From: [Orlando Furioso](#)
To: [Plan Commission Comments](#); [All Alders](#); [Abbas, Syed](#); [Leah Hugo](#)
Subject: Please Support CN Park Zoning and Oppose Roth-Ruskin-Huxley Street Remapping
Date: Monday, March 7, 2022 3:01:35 PM

Opposition to the proposed street reservation.

Agenda Item: 15. Legistar ID [69519](#) Amending the City of Madison Official Map to establish mapped reservations for future Streets and Highways in the City of Madison consistent with recommendations in the adopted Oscar Mayer Special Area Plan.

Hartmeyer Property
Tracks (47DA54) mound group
Madison, Wi

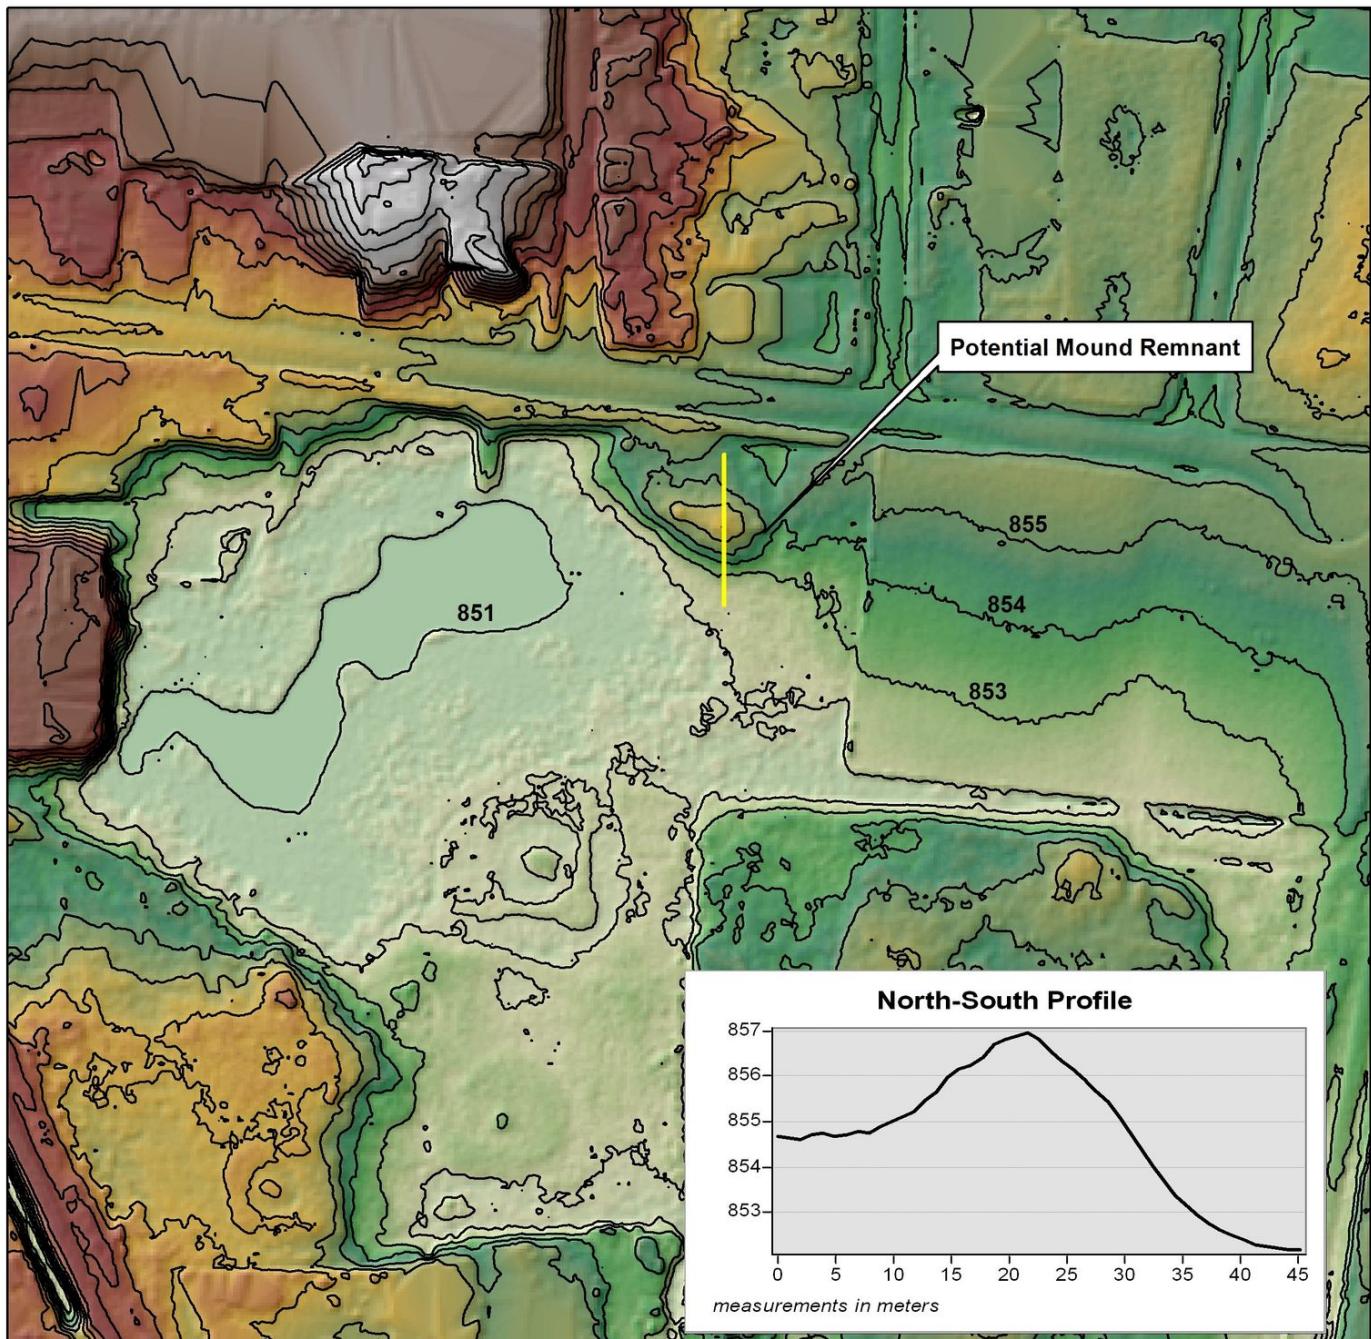
I am opposed to any disturbance to this area near the trees and that an archeological survey of this site is conducted to ensure that no artifacts or human burial remains are within this area. As you can see on the to scale drawing below, the road is well within the area of the mound and trees. As we look at redevelopment on this parcel of sacred ground, we need to proceed with caution and with our hearts aligned with doing no harm and protecting this cultural resource.

Proposed Zoning Map Area & Street Reservation **Yellow Border** = 14.81 Acres

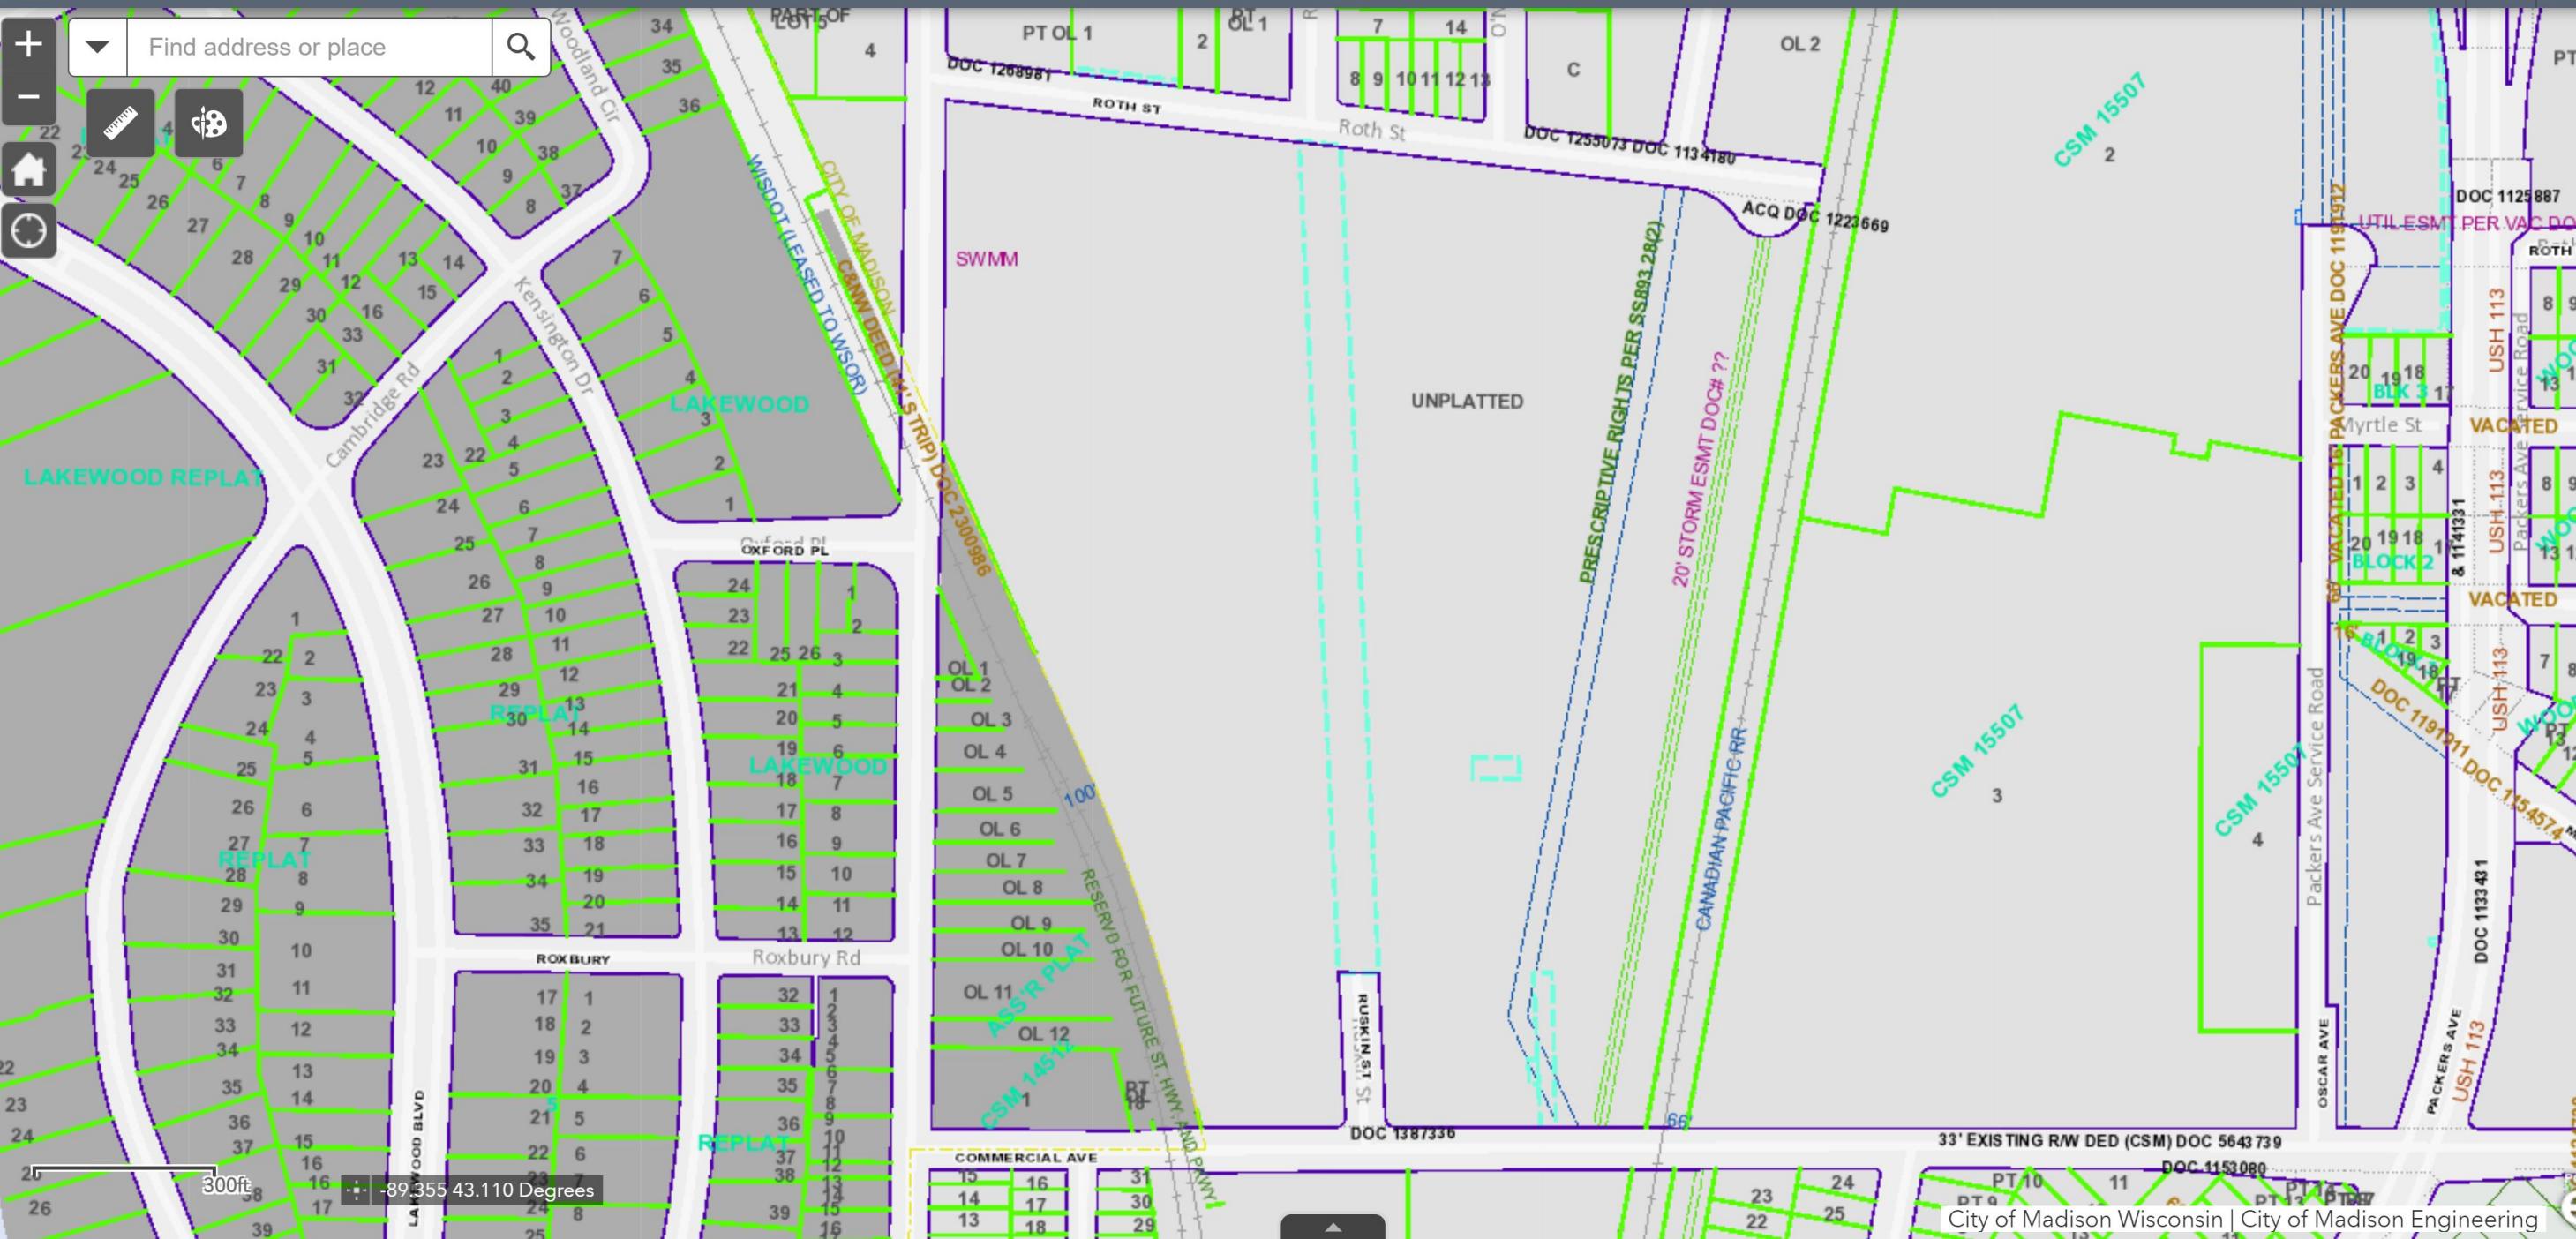
Red Border = 16 Acre Calculated and Scaled Area shifting North, East and South Boundaries, restoring 1.19 Acres lost by Zoning and Street Reservation Map Boundaries, to comply to Common Council action, July 2020, for preservation of 16 Acres Total Wetland, Green Space & Cultural and Historical Resources Area.
